Power Trim Leak Down - 40 Thru 115

This is a revision of Outboard Service Bulletin 93-22. Destroy Bulletin 93-22 and insert Bulletin 93-22A. Changes are underlined>.

Mariner And Mercury

1993 and 1994 40 Thru 115

Figure 1. Date Code Location.

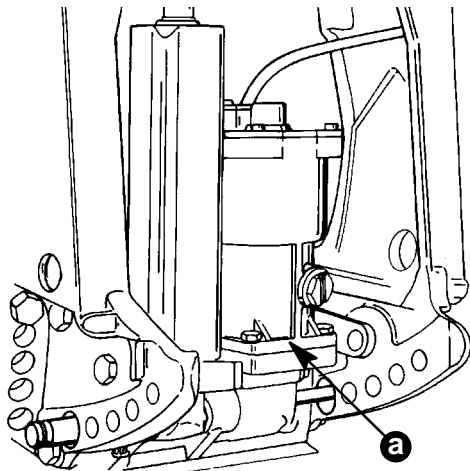
The 1993 and 1994 models listed with power trim date codes 13011 thru 23288 ONLY may experience a very slow up trim rate (one minute or more) with the outboard drifting back down as soon as the UP trim button is released. This failure usually occurs when the unit is new or after three or four weeks of non use. The cause may be a stuck spool inside the sleeve due to an oversize or a hard O-ring on the spool.

Figure 2. Side View of Manifold.

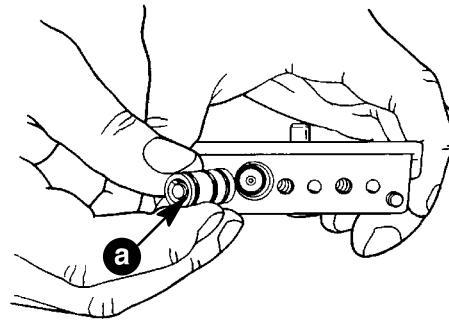
To correct, remove the tilt cylinder from the manifold and replace the pilot valve assembly as outlined in the outboard service manual. It is NOT necessary to replace the complete power trim to correct the problem.

Figure 4. Spool Not Stuck.

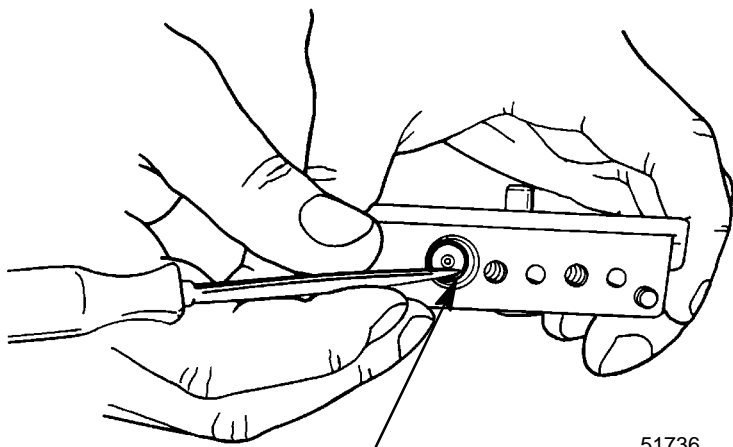
The spool is stuck when the pin end of the spool is protruding out past the end of the sleeve.

Figure 6. Pilot Valve Held Open.

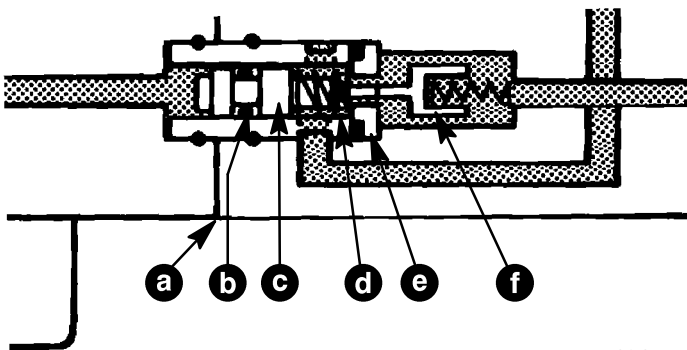
A leak path is created between the UP side of the cylinder and the reservoir, when the spool sticks holding the pilot valve open.

Replacement parts are contained in the screw and seal kits listed.

Figure 7. Pilot Valve End.

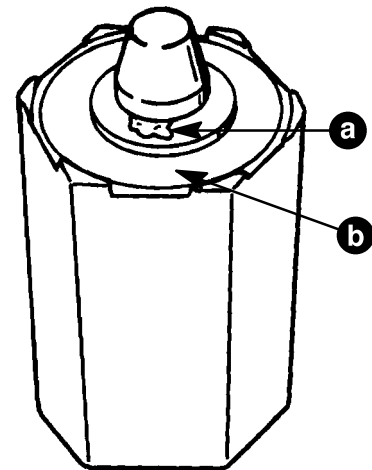
To correct a slow leak down, check for debris between the valve seat and valve.
